**Torrens Section 33 Block 9 – Certificate of Design Acceptance**

**DA ASSESSMENT – Merit Track**

Block/s:	9	DA number:	202037990
Section:	33	Date lodged:	27-Nov-20
Suburb:	Torrens	Due date:	13/01/2021
Zone/s:	<b>Territory Plan - Land Use Zone:</b> RZ1: SUBURBAN	Unit Number (if applicable)	
Proposal:	PROPOSAL FOR DUAL OCCUPANCY - Construction of 2 new dwellings, garages, tree removal, verge alterations and associated works.		
Proposed Use:	Residential – Dual Occupancy		
Is the proposed use permissible under the zone development table or Crown Lease	<input checked="" type="checkbox"/> Yes - under development table <input type="checkbox"/> No - under development table <input checked="" type="checkbox"/> Yes - in Crown Lease <input type="checkbox"/> No - in Crown Lease <input checked="" type="checkbox"/> <b>Other – specify:</b> <b>Stage 4 – Check DA Leasing comment</b>

DRAWING TITLE - ELEVATIONS RESIDENCE 1  
CLIENT - FORTIFIED BUILDING GROUP

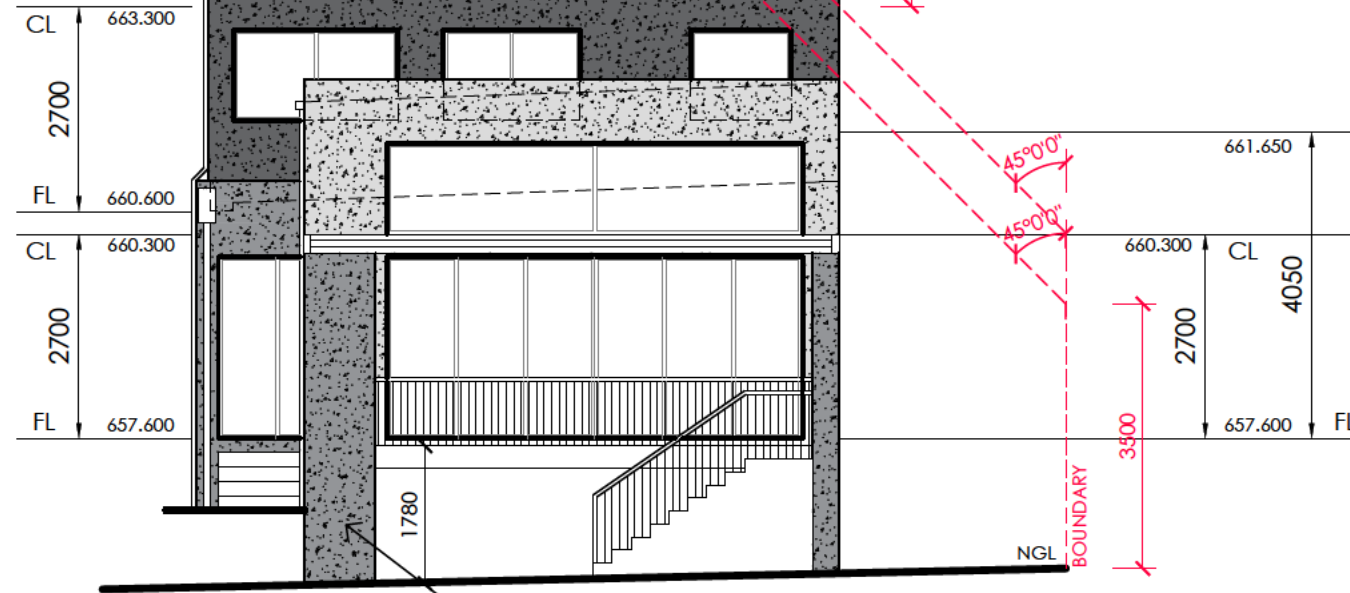
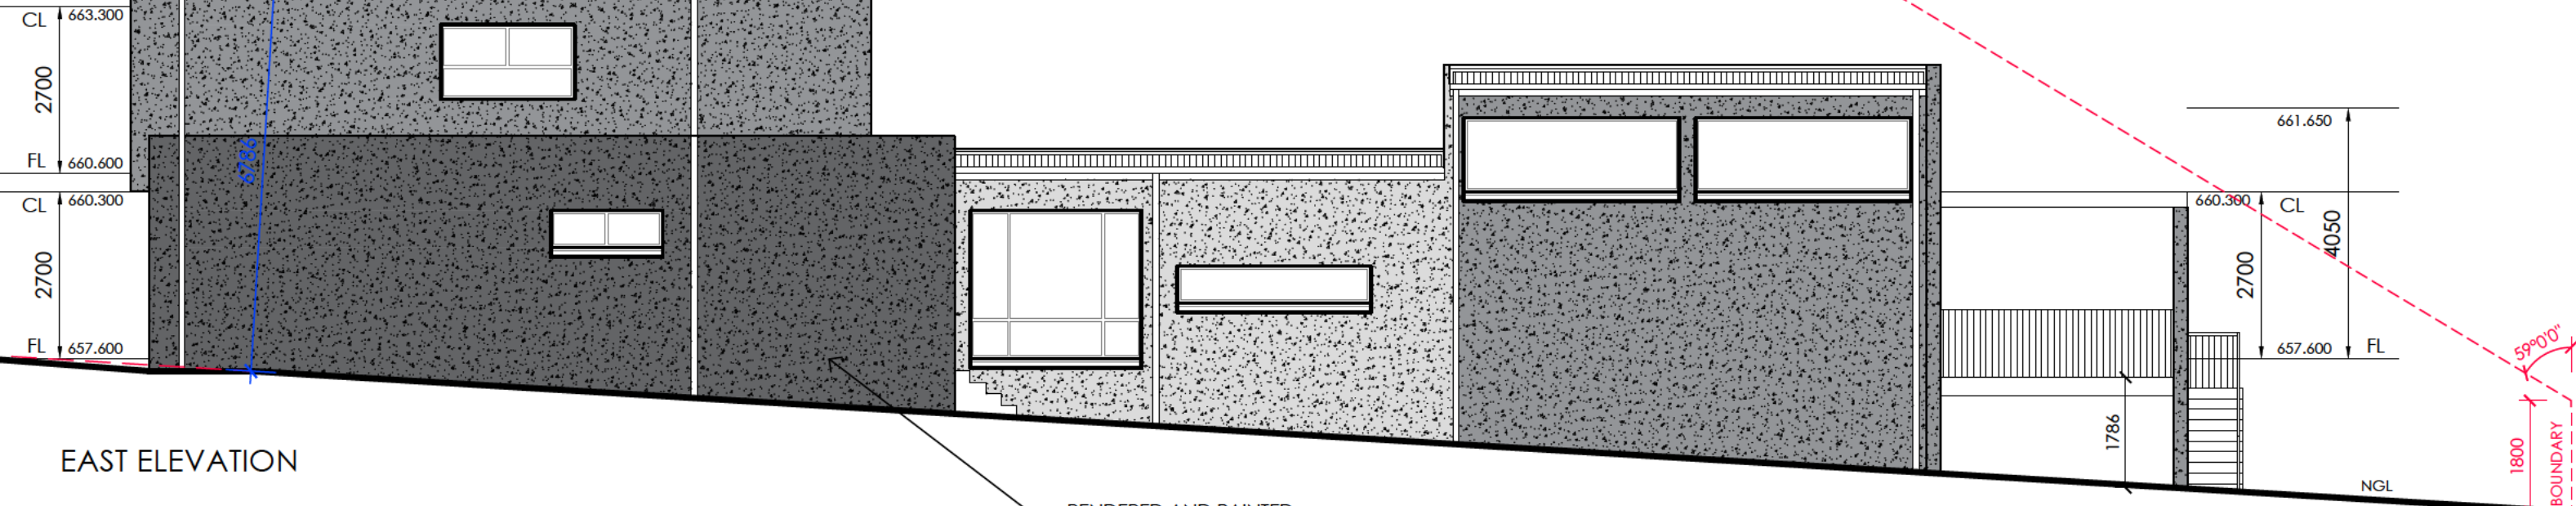
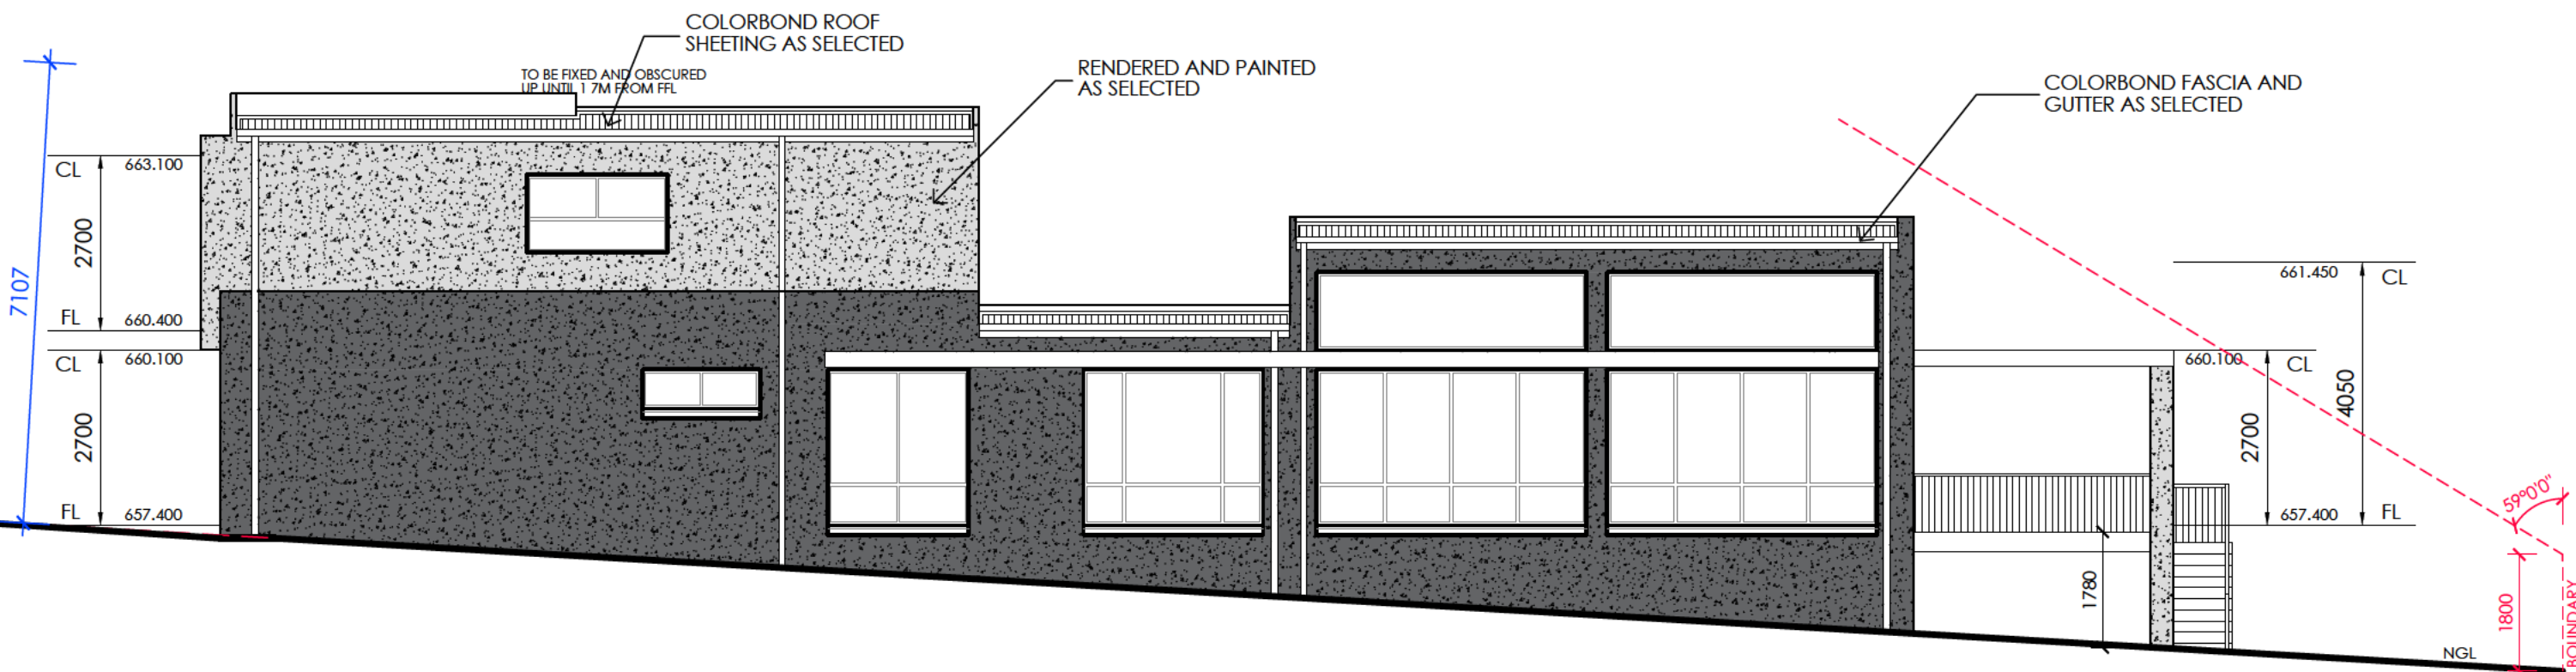
**Recommend addition of a condition of approval for front and side elevations to incorporate additional material palette and/or articulation elements such as timber or timber like cladding or bricks or other material to soften the appearance of the front elevation to the satisfaction of the Planning and Land Authority.;**

**To mitigate privacy impact onto adjoining properties, condition is recommended in Stage 4 for the upper level windows for both unit 1 and 2 facing the side boundaries are to be provided with opaque glazing to minimum height of 1700mm above the finished floor level (R59/C59 & R60/C60 of the MUHDC).**

R49/C49	<p>Building design – Wall articulation and materiality could be improved to reduce the severity of the front and side elevations, which also responds to concerns raised in the representation.</p>
	R59/C59; R60/C60	<p>Windows with sill heights less than 1800mm are proposed for upper level elevations of Units 1 and 2, and they are setback 3m from respective side boundaries, which may lead to direct overlooking into primary windows of adjoining dwellings and their principal private open space.</p> <p><b>Recommend condition:</b> <b>To mitigate privacy impact onto adjoining properties, upper level windows facing the side boundaries are to be provided with opaque glazing to minimum height of 1700mm above the finished floor level.</b></p> <p>Rule 59 applies to dwelling on the same block – AY 30/3/2021 R60 – window 23 and 24 won't have direct line of sight into the PPOS of Block 10.</p>

TO BE FIXED AND OBSCURED UP UNTIL 1.7M FROM FFL
